Process Sheet

Drawing Name : TUBE ASSEMBLY

Part Number : D2003045

DESIGN <i>[Signature]</i>	DRAWN BY <i>[Signature]</i>	DART AEROSPACE LTD HAWKESBURY, ONTARIO, CANADA	
CHECKED <i>[Signature]</i>	APPROVED <i>[Signature]</i>	DRAWING NO. D2003	REV. B SHEET 2 OF 2
DATE 99.06.08	TITLE 206 CABIN HEATER TUBE ASSEMBLIES NTS

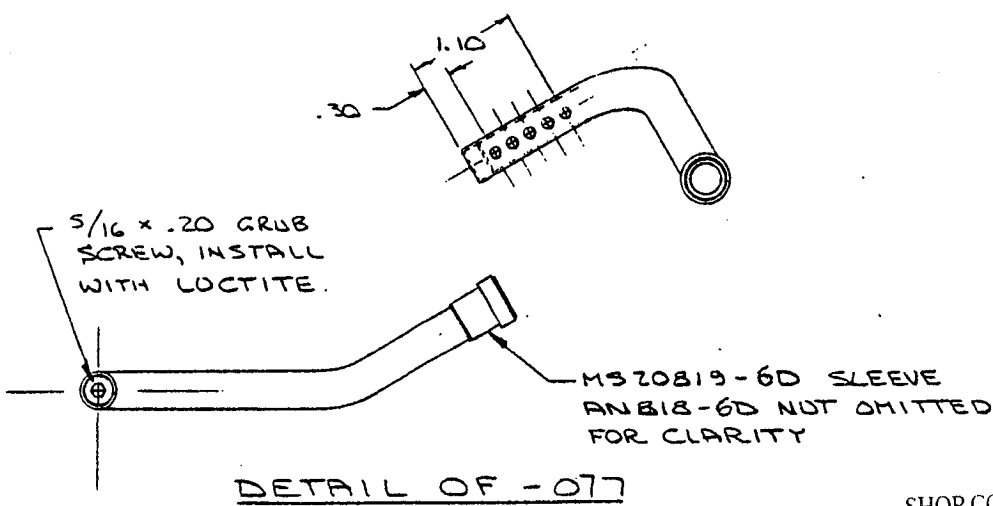
UNDER REVIEW

Some flat lengths
and wrong
